ML 2M LOUDSPEAKER SYSTEM

SERVICE INFORMATION

SERVICE BULLETIN

REPLACEMENT OF 8" LOUDSPEAKER 036-002

SYSTEM SCHEMATIC

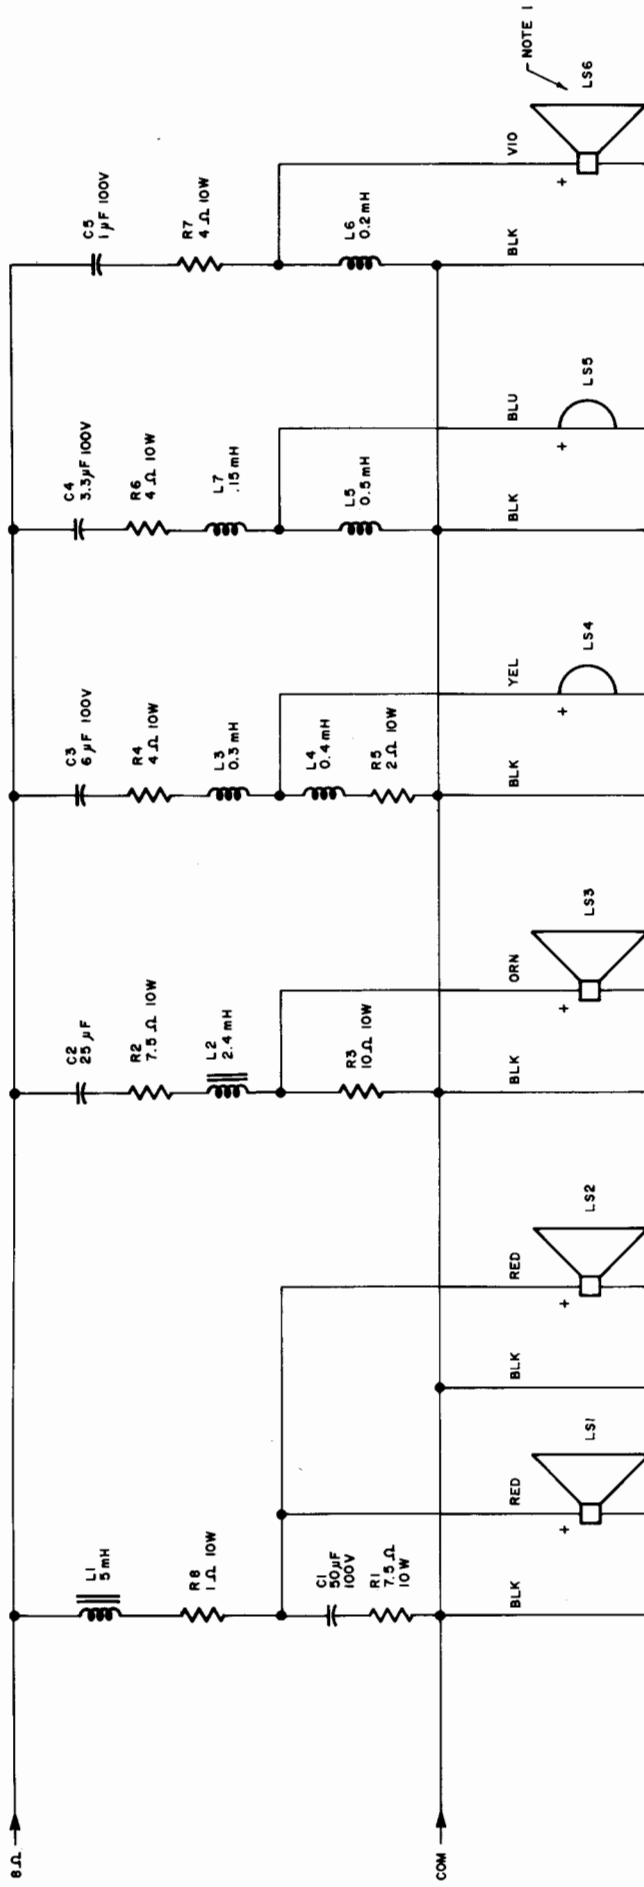
PURPOSE OF MODIFICATION: To maintain the same acoustic output.

WHAT UNITS ARE AFFECTED: ML-2C Serial No. L1C001 through L1C429.
ML-2M Serial No. L1D001 through L1D145.

WHEN MODIFICATION SHOULD BE MADE: When replacing defective 036-002 8" loudspeaker.

QUANTITY	PART NUMBER	DESCRIPTION
1	139-090	Wirewound Resistor: 7.5Ω, 10W
1	036-025	8" Loudspeaker

- Step 1 Remove rear panel.
- Step 2 Locate 10Ω, 10 watt resistor in series with the 8" loudspeaker. Remove and replace with 7.5Ω, 10 watt resistor.
- Step 3 Replace rear panel.
